CONVERSION SET REAR 977 EVO2 #903657

Serpent introduces for the Viper 977 this rear-end • upgrade set.

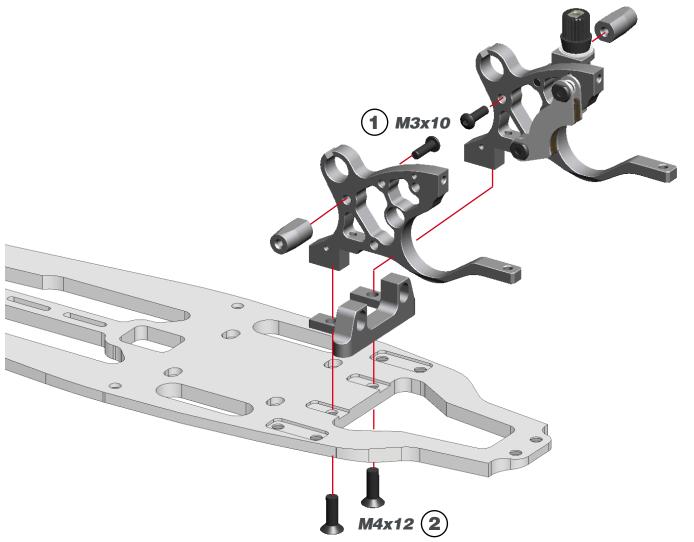
The parts included allow you to create a new rear end geometry, with longer pivot balls, the lower suspension pins moved closer together, combined with a new camber bracket.

This creates an easier Viper 977 car with more traction (acceleration and braking) and higher corner speeds.

The set only includes the parts as needed for the upgrade. All other parts shown in the manual are used from the existing car.
